ORCHARD RANCH
SUBDIVISION
CONSTRUCTION PLANS

GRADING PLAN (1 OF 2)

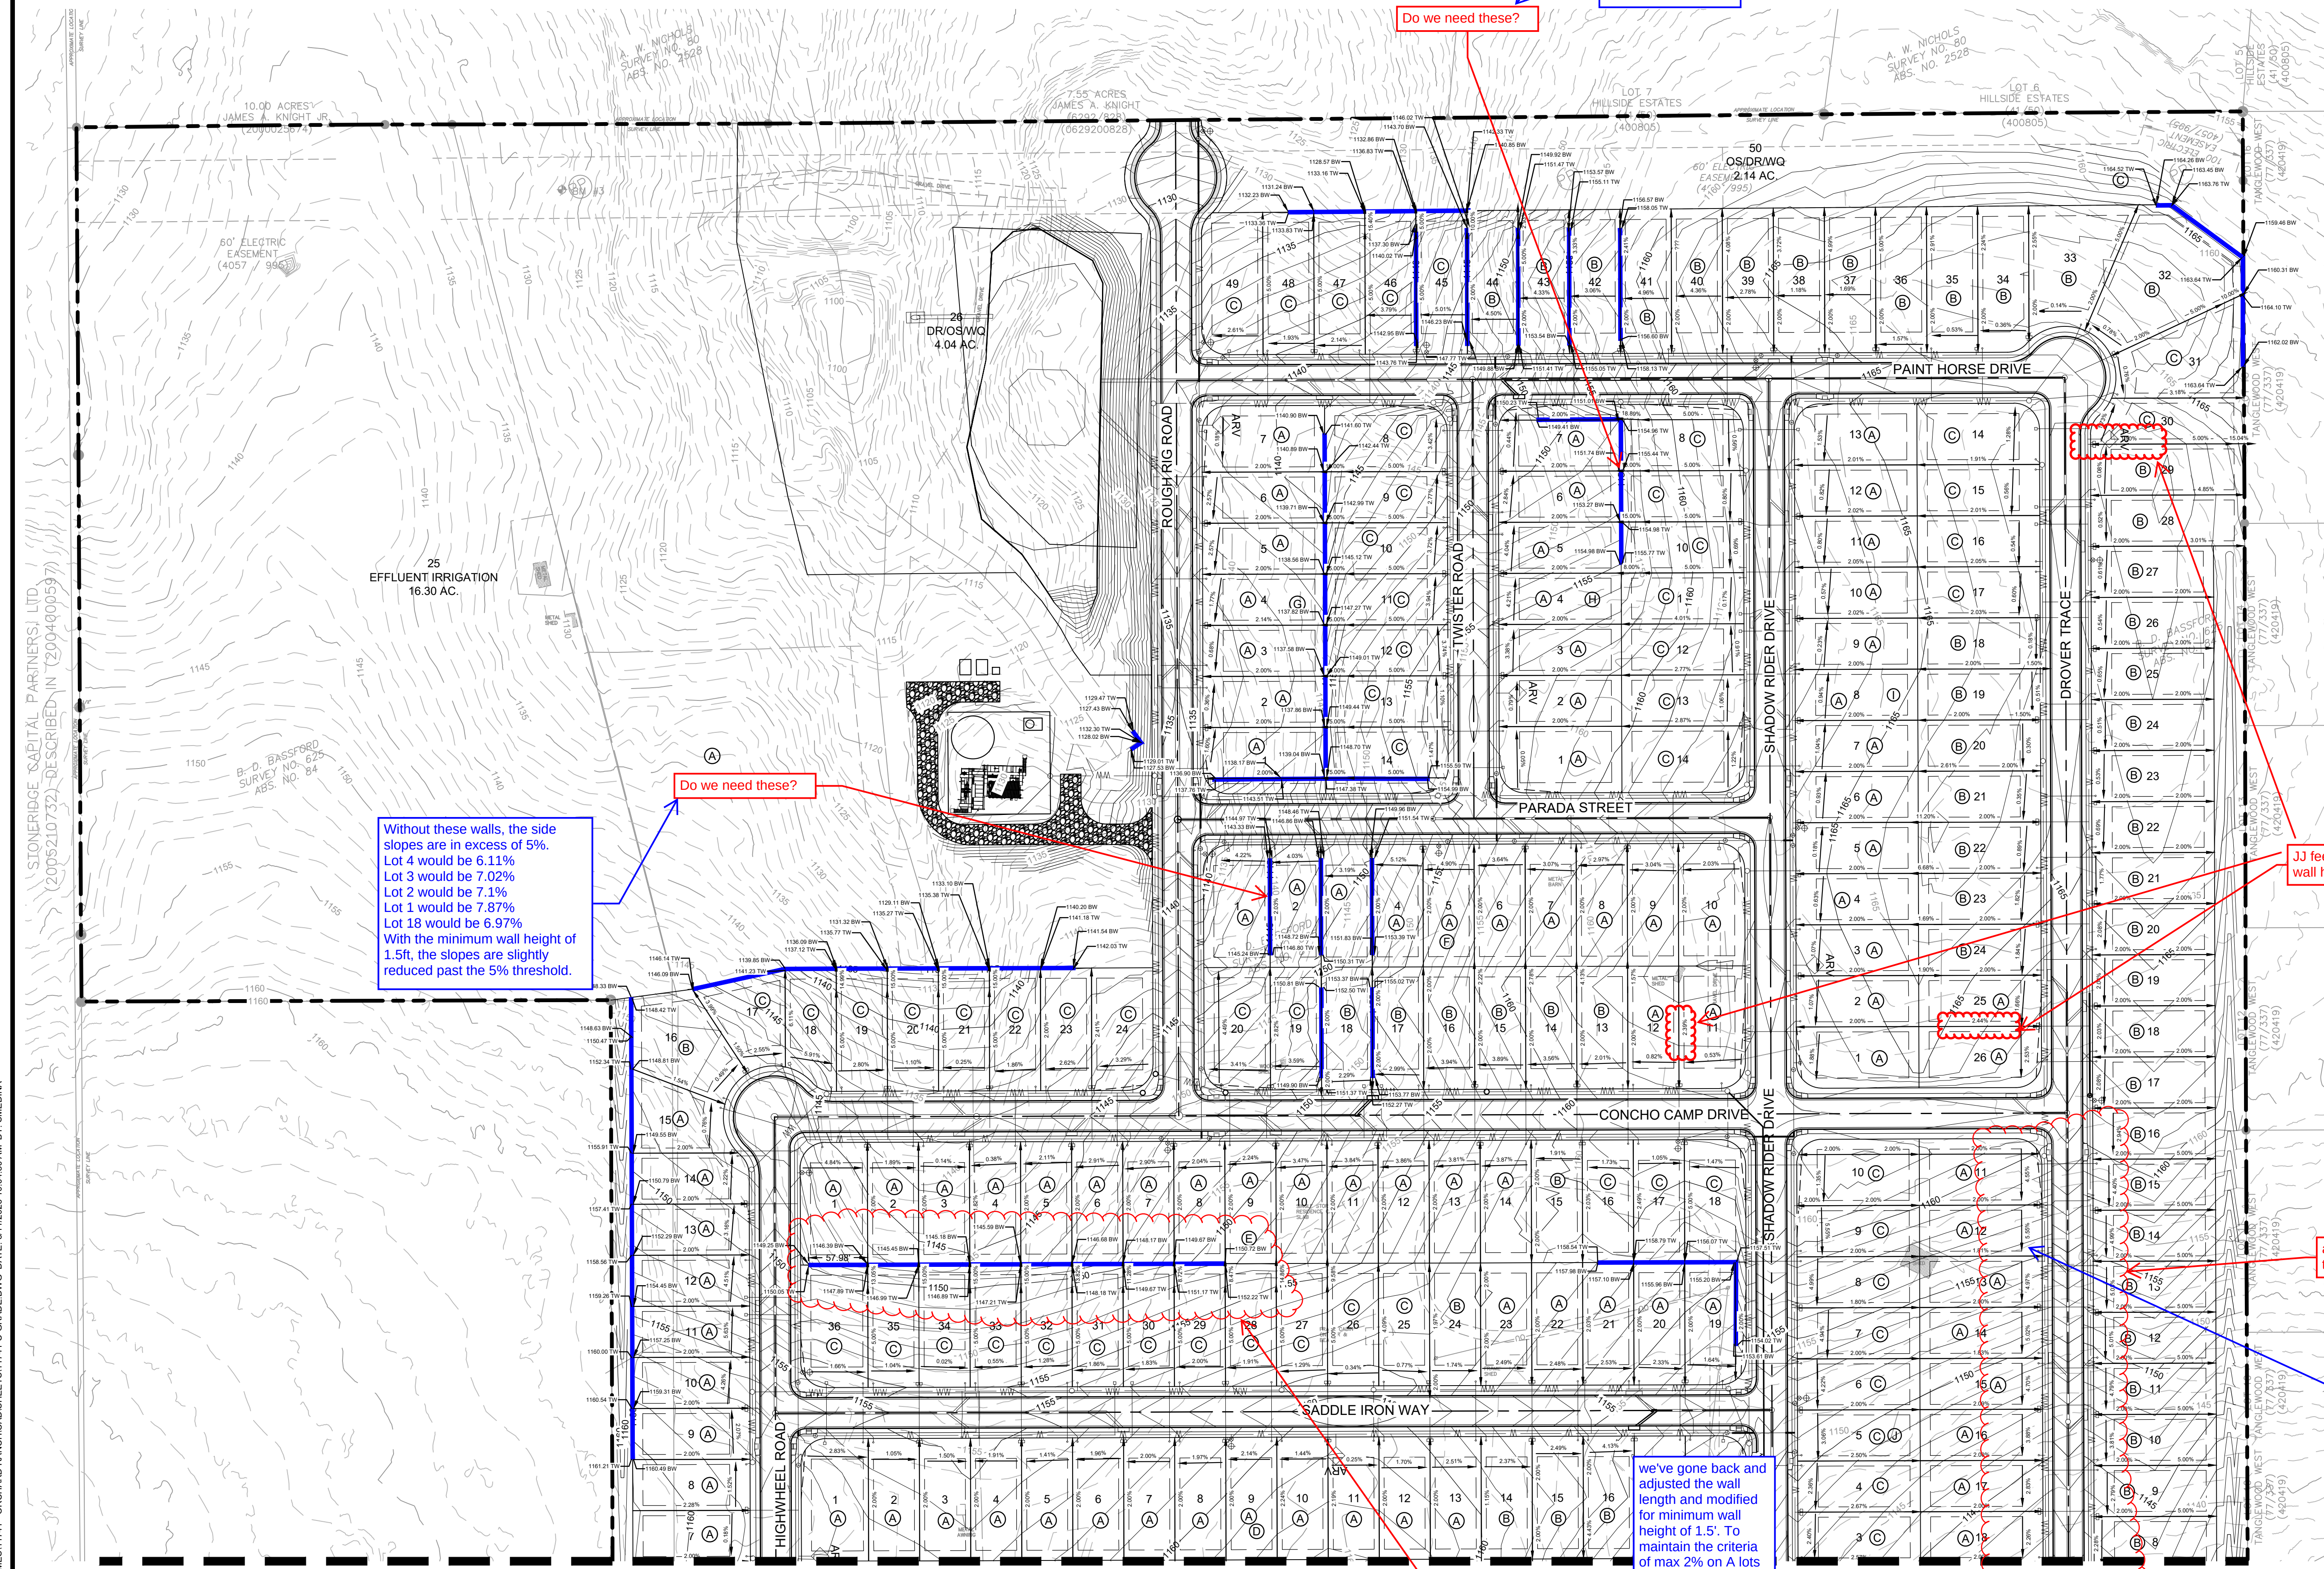
Do we need these?

Do we need these?

JJ feels good w/o wall here

are we okay with these slide slopes?

can we reduce these by length?

Without these walls, the side slopes are in excess of 5%.
Lot 4 would be 6.11%
Lot 3 would be 7.02%
Lot 2 would be 7.1%
Lot 1 would be 7.87%
Lot 18 would be 6.97%
With the minimum wall height of 1.5ft, the slopes are slightly reduced past the 5% threshold.

To maintain the criteria being used here (5% max slope through the C lot pad with a 15% backyard and 2% max slope on the A-lot) we would need the walls.

10-4

We've adjusted some of the slope labels that were not completely parallel to lot lines. Lot 12 on block J is really the only slope that is of concern. We could implement a sideyard wall if the slope is deemed unacceptable.

we've gone back and adjusted the wall length and modified for minimum wall height of 1.5'. To maintain the criteria of max 2% on A lots and 15% backyards on C lots, the remainder of the walls are needed. For example: Lot 28 back yard would be at 16.1% Lot 29 would be 16.4% Lot 30 would be at 18.5%
